# Harnett County Department of Public Health

PERMIT # SFD 2503-0024

## Operation Permit

# Tobacco Road PH 2

As Built

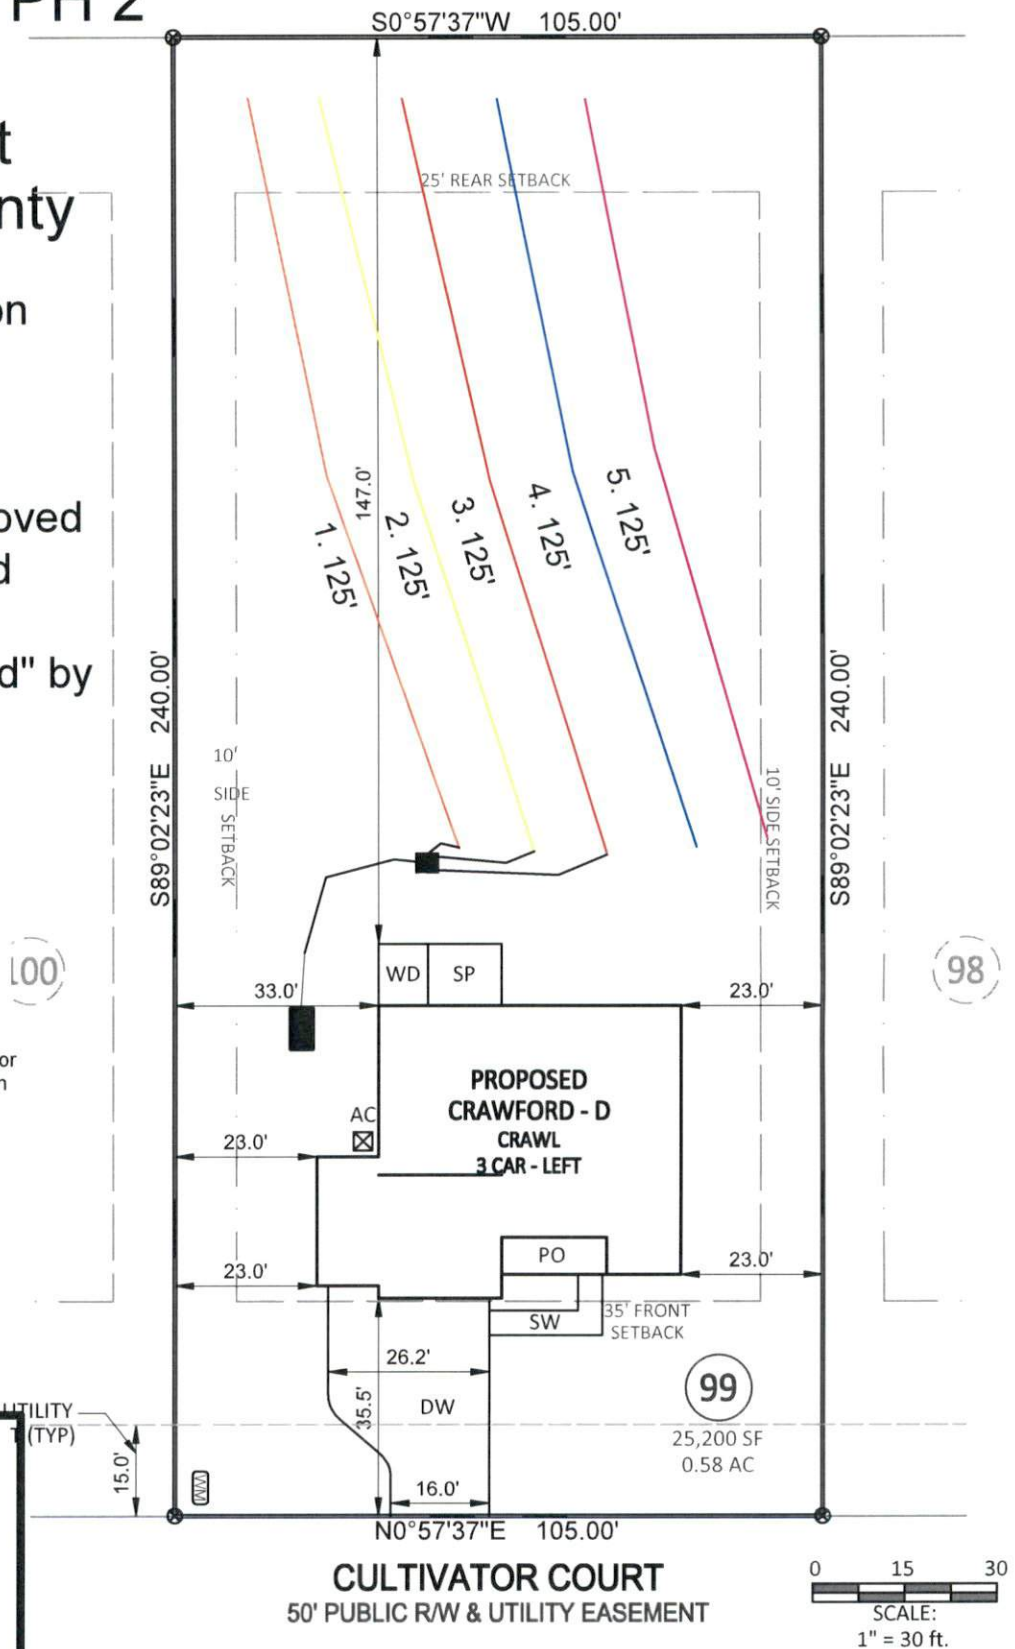
\*At time of installation contractor was able to dose septic field with gravity, so pump tank was removed and system changed to gravity to D-Box - Change is "Approved" by Alex Adams

Lines 1-3 (375')  
Accepted Status  
Gravity to D-Box
